RE: 2021 Cost-of-Service Rate Application EB-2020-0040

In accordance with the Ontario Energy Board's Procedural Order No. 1, issued on October 13, 2020, Niagara Peninsula Energy Inc. ("NPEI") hereby submits its interrogatory responses.

INTERROGATORY RESPONSES

Ref 1: Exhibit 2, Appendix 2-8, Distribution System Plan, Projects Table Reference #53 Pole Replacement Program, Page 393 of 1059

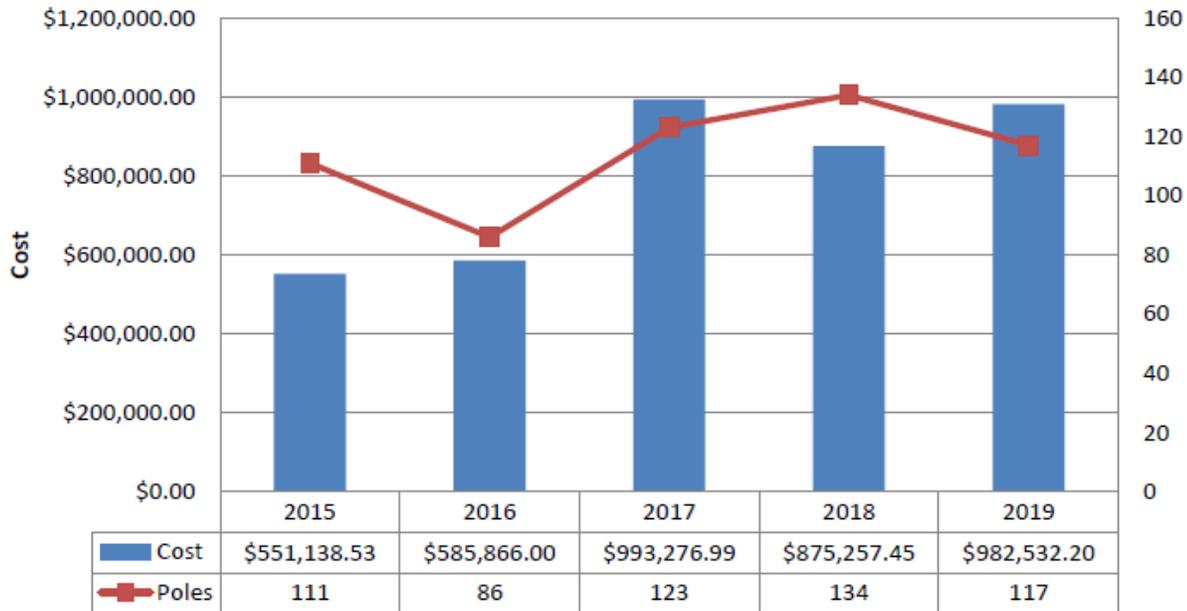
Niagara Peninsula Energy stated that “The table below summarizes the pole replacement program from 2015 to 2019. Over this period, the average cost to replace a pole was \$6,841.”

The following table shows the average cost per year to replace poles between 2015 and 2019:

Ref 1: Exhibit 2, Appendix 2-8, Distribution System Plan, Appendix 2-AA Capital Projects Table Reference #54 Kiosk Replacement Program with Pad Mounted Transformers, Page 364 of 1059

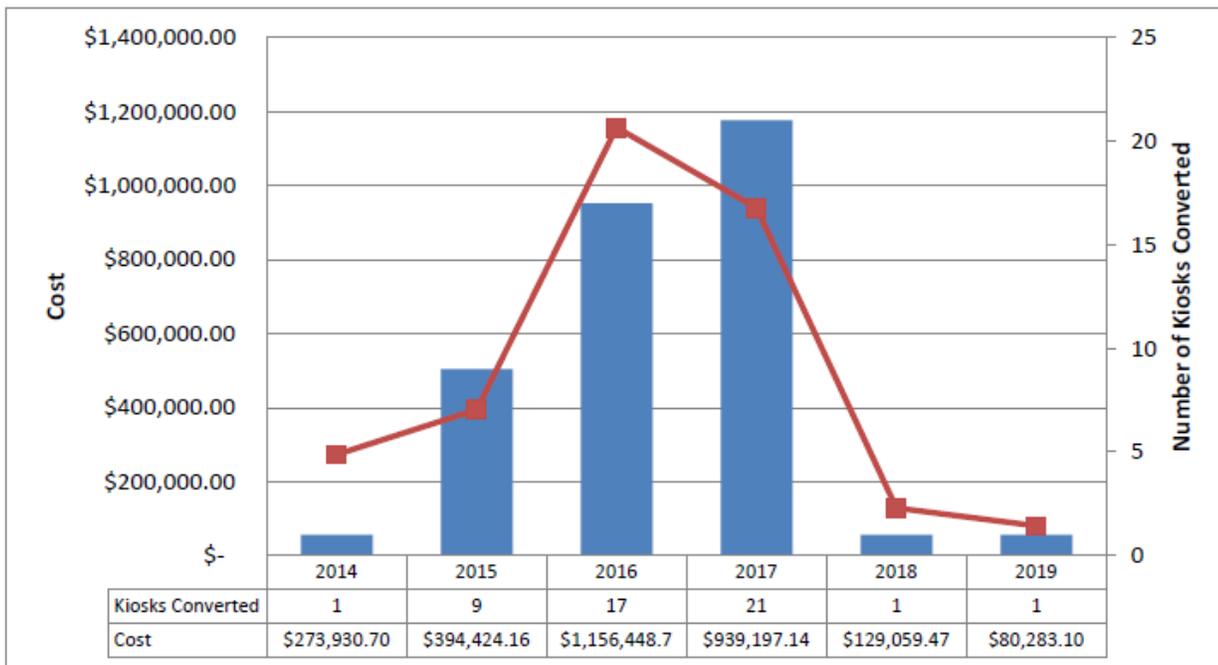
Niagara Peninsula Energy stated that “This Capital Program is an integral part of the remediation of underground distribution systems, increasing longevity and reliability within the area serviced. As these legacy components are replaced, safety, reliability and service quality are significantly improved. For 2021 the plan is to replace approximately 11 units.”

Niagara Peninsula Energy further stated that “The cost can vary from kiosk to kiosk as each project is unique. In some cases, the rebuild may only involve the installation of new pad mounted distribution in place of the existing kiosk. While, in other cases a new location for the new equipment may be required to improve accessibility.

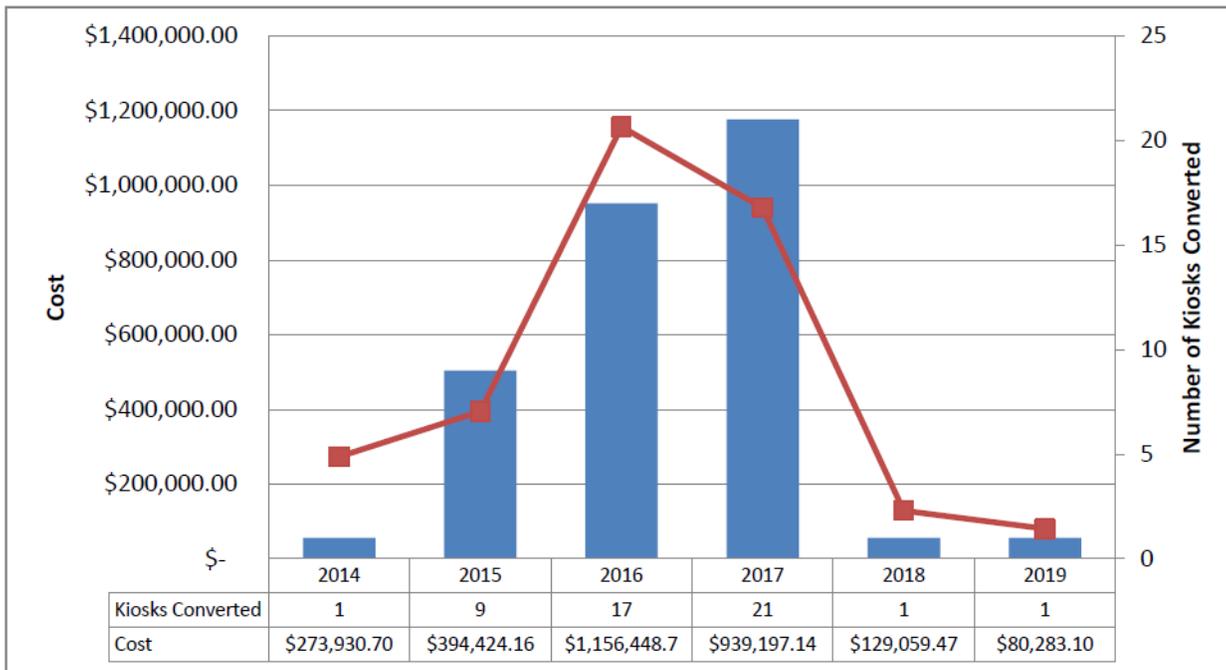
- b) Please show the number of polemount transformers replaced under the pole mount transformer project (i.e. that are not as part of other system renewal programs in each year 2015 through 2025 forecast).

This is a new program as of 2021. The forecasted values for 2021 - 2025 are 50 transformers per year.

Outages Caused By Pad-Mount Trasformers

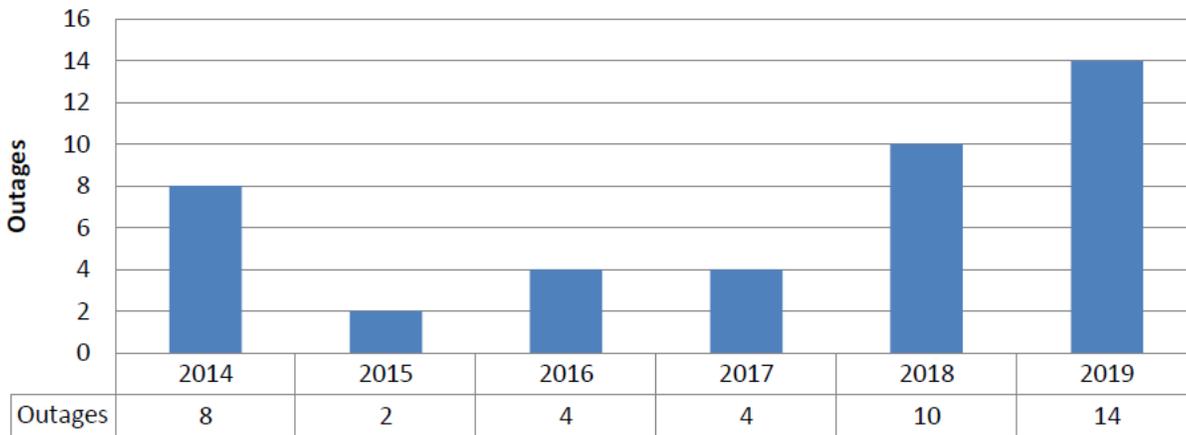
- a) A number of capital projects, including the Pad-Mounted Transformer Replacement project are being undertaken to reduce outages due to equipment failure. Please provide the target improvement for outages from Defective Equipment (or expressed as Customer Hours of Interruptions by Defective Equipment) that NPEI is expecting to achieve from these projects.

The pad mounted transformer replacement program starts in 2021. Refer to the capital project summary included in Exhibit 2, Appendix 2-8, Distribution System Plan, Appendix A for the requested details.

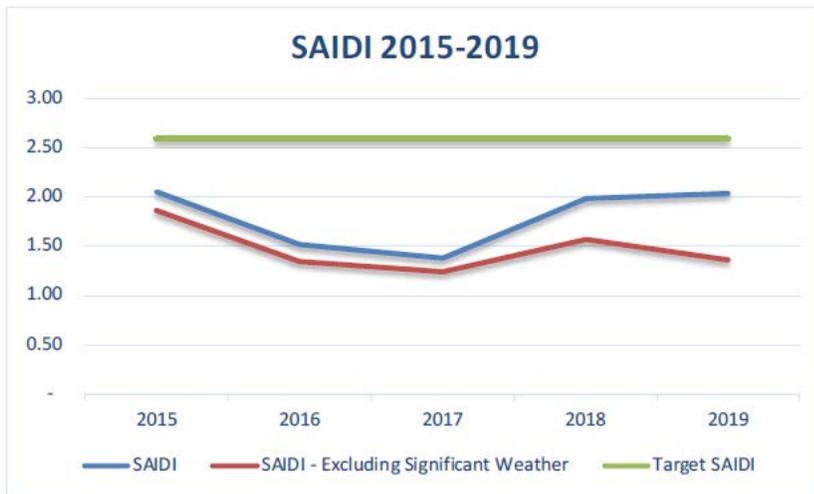
- a) Please provide the actual number of poles replaced under the pole replacement program in each year 2014 through 2019 and the forecast number for years 2020 through 2025.

2014 = 52
2015 = 111
2016 = 86
2017 = 123
2018 = 134
2019 = 117

NPEI plans to replace approximately 100 poles per year from 2021 to 2025 under the Pole Replacement Program.
